REMARKS

DISCUSSION

Application Serial No. 10/691,678
Amendment Dated 09 December 2004
Reply to Office Action of 14 September 2004
Replacement Drawing Sheet

FIG.1

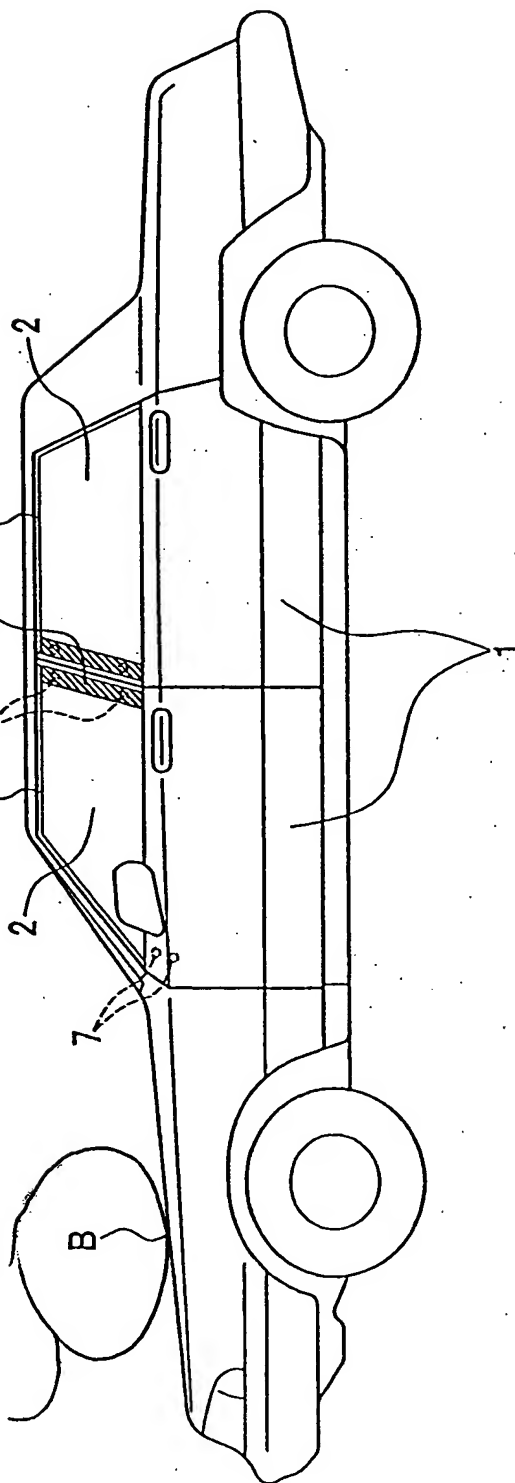
In the present amendment, this objection has been overcome by amendments to the specification to add reference numbers C, D, and 19b, and by amending Figure 1 of the drawings to remove reference character B therefrom.

Please amend Figures 1 and 6 of the drawings, according to the attached replacement sheets for Figures 1 and 6. In Figure 1, the reference character B and its associated lead line have been deleted, pursuant to the suggestion of the Examiner. In Figure 6, the words "PRIOR ART" have been added to more clearly indicate that the subject matter of the Figure is prior art included for discussion purposes.

*Ref. character
and lead line removed*

FIG. 6

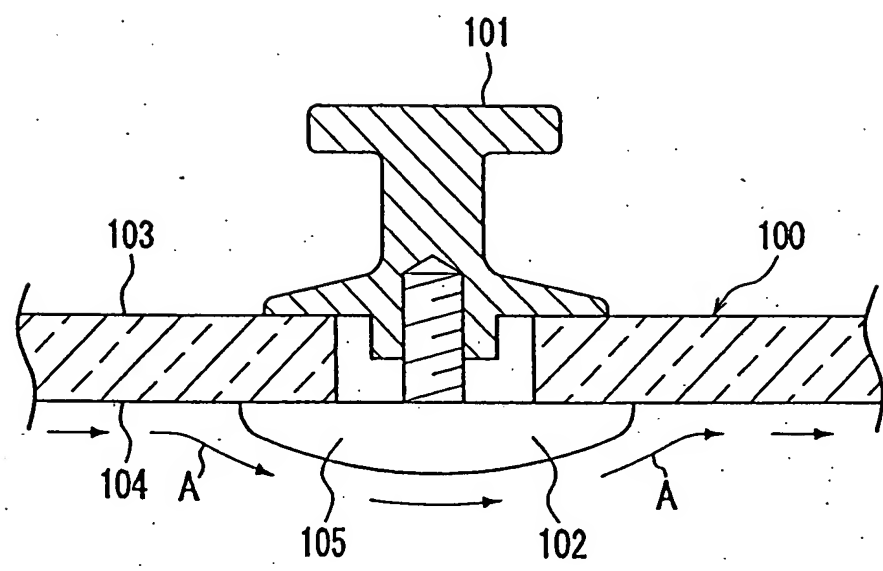
Words have been added
